HISTORIC AND DESIGN REVIEW COMMISSION

HDRC CASE NO: 2022-346
ADDRESS: 506 STIEREN
LEGAL DESCRIPTION: NCB 2966 (STIEREN STREET REPLAT), BLOCK 1 LOT 18
ZONING: RM-4, H
CITY COUNCIL DIST.: 1
DISTRICT: King William Historic District
APPLICANT: Caroline Gado
OWNER: APOLLO MAYORAL LLC
TYPE OF WORK: New construction of four, multi-story structures
APPLICATION RECEIVED: June 13, 2022
60-DAY REVIEW: Not applicable due to City Council Emergency Orders
CASE MANAGER: Rachel Rettaliata

REQUEST:

The applicant is requesting conceptual approval to construct four residential structures on the lot addressed 506 Stieren. The proposal includes three, 3-story structures and one, 2-story structure.

REVISIONS:

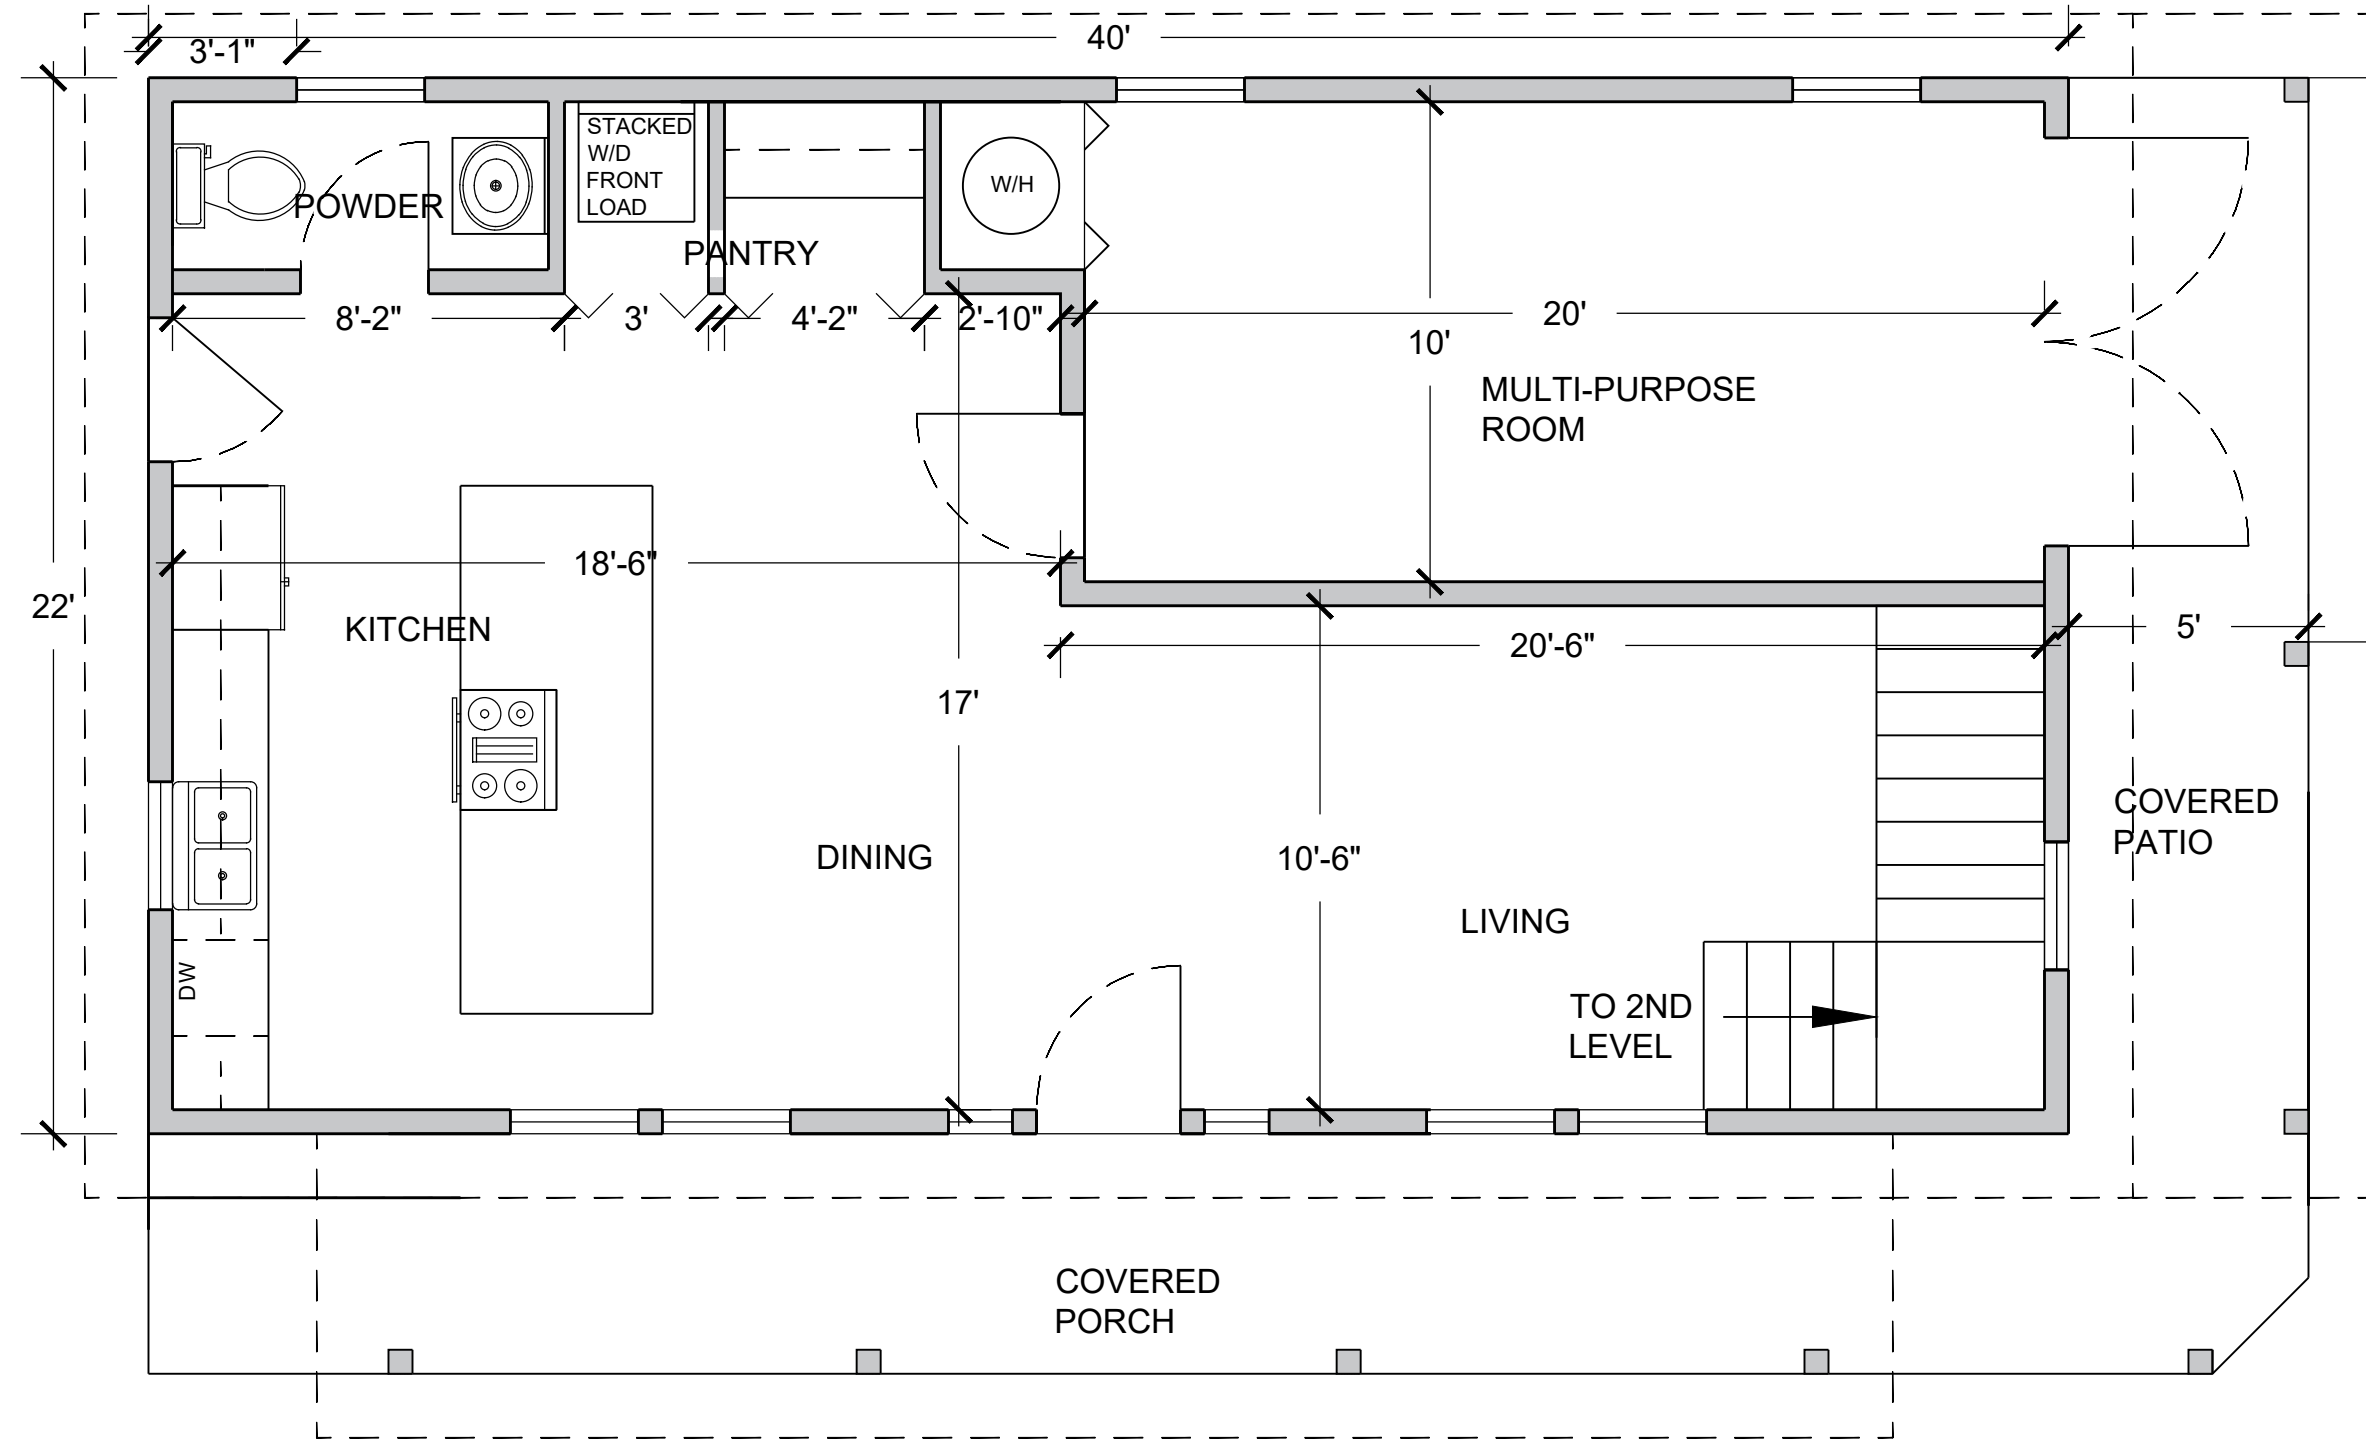
- g. **SCALE & MASSING** – The applicant has proposed to construct four detached residential structures, including three, 3-story residential structures and one, 2-story residential structure. The front building along Stieren will feature the tallest height at approximately 34'-6", with the remaining houses stepping down in height as the lot moves south from 33'-3" to 30'-9" to 27'-3". According to the Historic Design Guidelines, new construction should not exceed the height of the majority of existing structures by more than 1-story. The predominant surrounding residential context features 1-story residential and commercial structures. While there is presence of 2 and 2.5-story historic structures peppered along Cedar St, these taller structures typically feature a deeper setback than the 1-story structures. Staff does not find the proposed height consistent with the Guidelines.

- h. **ENTRANCES & PORCHES** – The applicant has proposed porch elements on all four structures. The front building along Stieren features a wraparound 2-story porch with a depth of 5 feet. The remaining interior buildings feature porches on the front facades fronting the shared interior driveway with varying depths that include recessed single-stall carports. Per the Guidelines for New Construction, The primary façade of new buildings should be in keeping with established patterns in terms of porches, entrances, orientation, and setbacks. Staff generally finds the front setback and porch design conceptually consistent, but as noted in finding f, finds the scale and massing inconsistent with the Guidelines. The height of the front building when combined with the narrow setback is also incongruous with overarching development patterns, which typically feature 1-story structures closer to the street and taller structures (2 to 2-½ stories) set further back from the street as noted in finding d.

CG: One “main” unit and 2 smaller units, the smallest unit at the rear, there are not garages, but there are covered patios. The main unit has big windows. Unit 2 is more narrow, same window styles. There is a covered porch on the first level. Unit 3 is similar to Unit 2. Unit 4 is the smallest of the 4 units, it is 2 stories but with the same front doors and window styles.

LG: Is the main structure oriented toward Stieren?

CG: The front doors are all oriented toward the neighbor, closest to Stieren. This is platted as just two of the lots.

LG: It looks like this development does not comply with the Design Guidelines. The Guidelines state that buildings should respect those that exist in the neighborhood, what’s the primary orientation of houses in the district. The Conservation Society would likely recommend a denial. Something that might work would be two units, like with your other project. And you will also need to consider the lot coverage, open space to coverage space. People who live in King William like the houses to face the street and this configuration is not normally acceptable in a historic district.

- ii. That the applicant increases the setback of the front unit to be more consistent with the development pattern of the district as noted in findings g and j.

- iii. That the applicant reduces the height of the front structure to 2 ½-stories as noted in finding f.
- iv. That the applicant reduces the heights of all three of the rear three structures to be subordinate to the primary structure as noted in finding f.
